SUBJECT: Exception request, PLM Subdivision

PROJECT PLM Subdivision Phase 2C

Design Exception 3-8-2010  
 Water Service in Public Sewer Easement

**RE: Item on 3/30/10 PW Committee Meeting: Design Exception Appeal; Water Service  
PLM Subdivision Phase 2C**  
CC: PLM Development

0+00 to 5+50  
Sanitary Sewer  
Plan and Profile

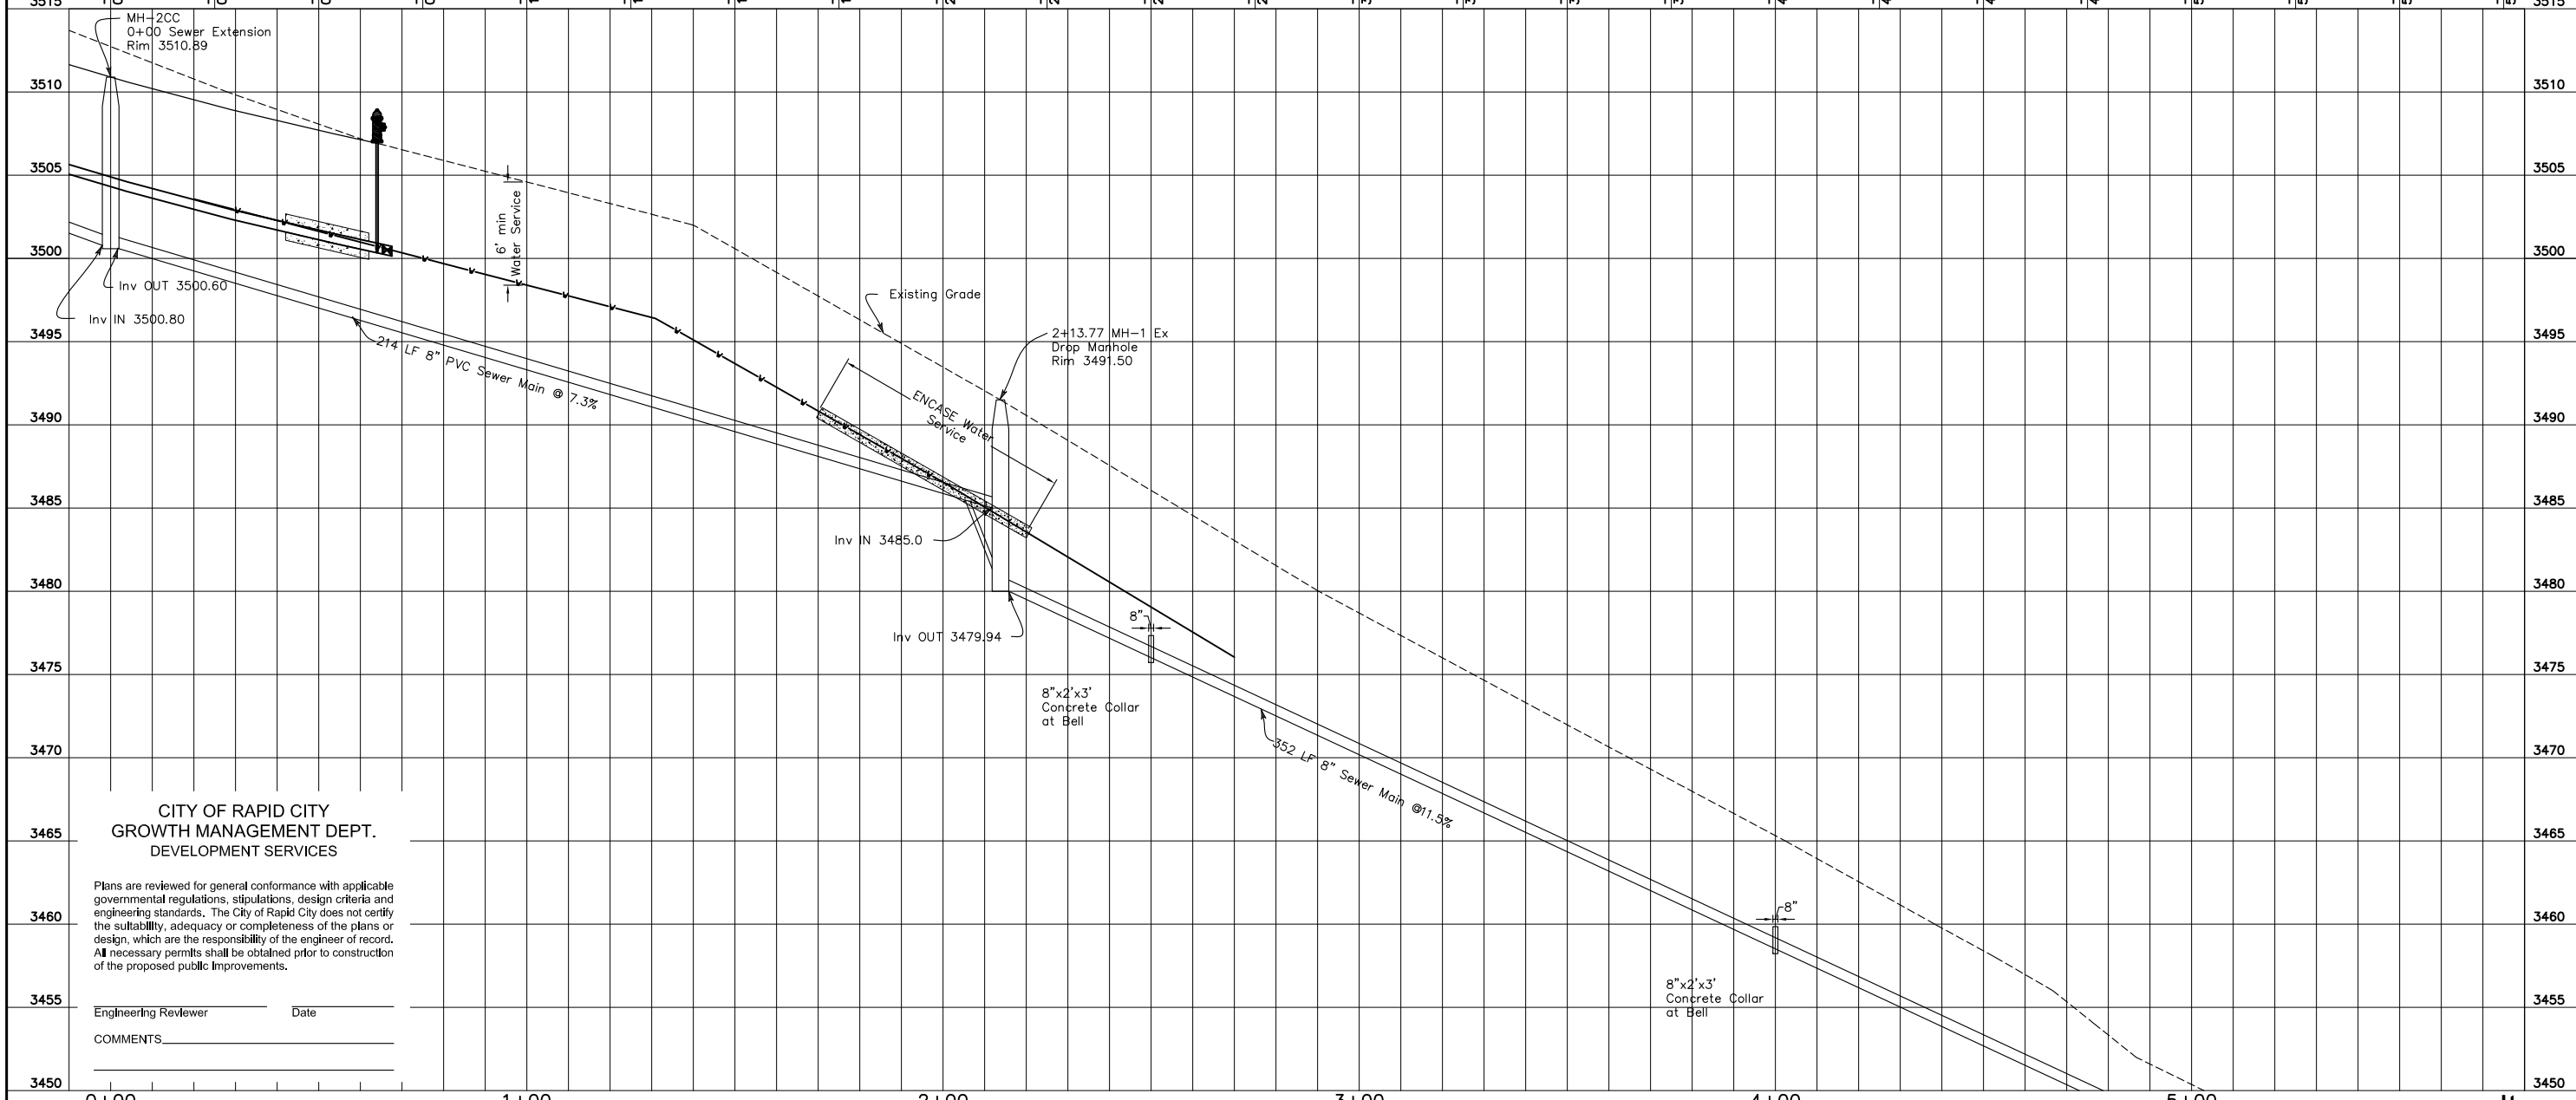
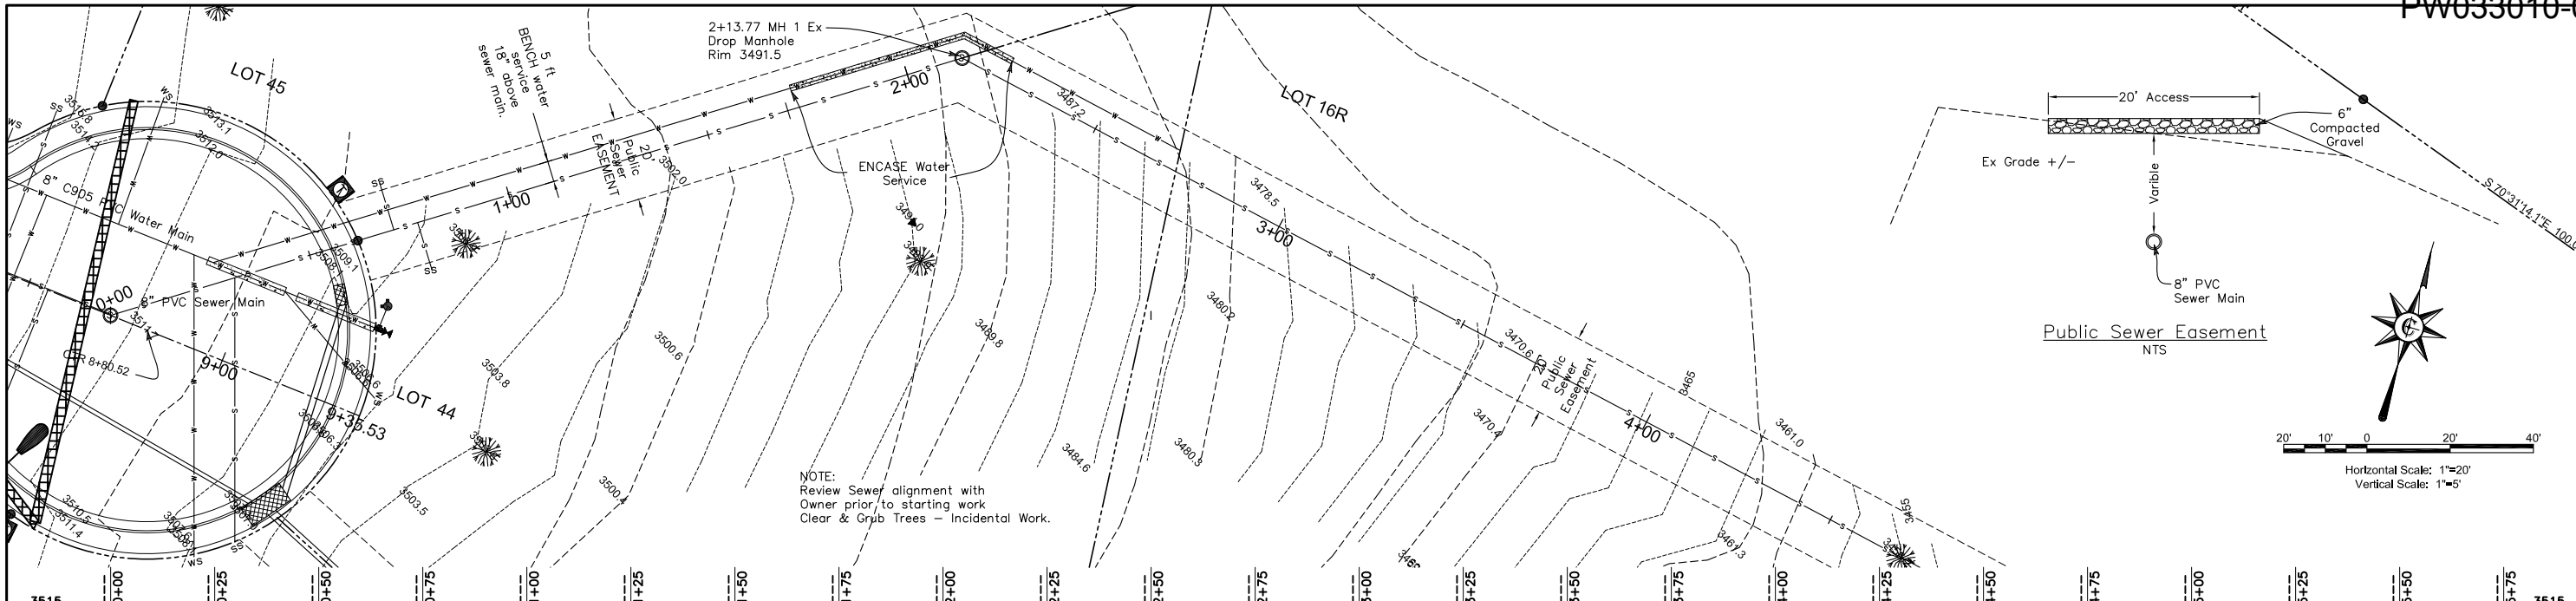
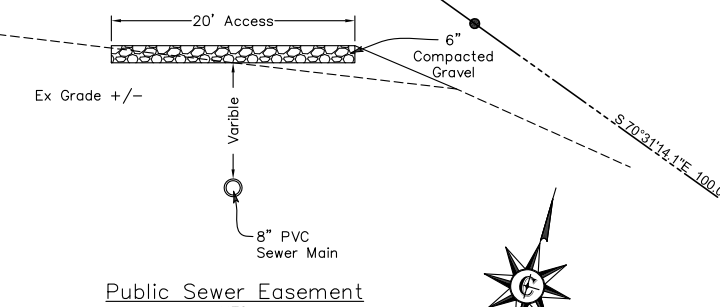
In this instance the terrain constraints are as difficult as the east end, but will allow for a comfortable corridor following 10 States guidelines and encasing where necessary. The attached drawing illustrates the strategy.
